December 26, 2003

RE: ENV-2002-2481-EIR; SCH#2002091018, Canyon Hills Project- DIR Comments

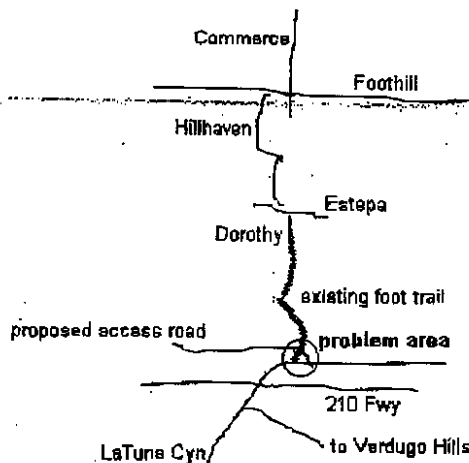
1. The draft EIR makes no mention of an important foot and bicycle trail that presently connects Tujunga directly to the Verdugo Hills. The proposed entry to the development will- as far as I can tell- cut off this trail completely. Depicted in a rough diagram below, this trail is the only available access to the Verdugo Hills from the residential areas of Tujunga. It is maintained by residents. The trail initially follows the power line access at Dorothy Road, then follows an abandoned road, and finally descends a steep grade to La Tuna Canyon Road near the bottom of the Hostetter Motorway (fire road). This last descent is very steep, and the proposed access road to the development area will, I believe, need to cut deep into and across the hillside in such a way as to make it impossible to hike around.

The draft EIR does not sufficiently describe the details of the proposed access road. Nor does it provide any plan for an alternate trail route. I use the above trail several times each week to access the Verdugo Hills on my bicycle. If this trail were cut off- as it appears to be in the draft

EIR- I will need to use my car to drive around via either Sunland or La Crescenta to gain the same access. I would very much like to avoid that.
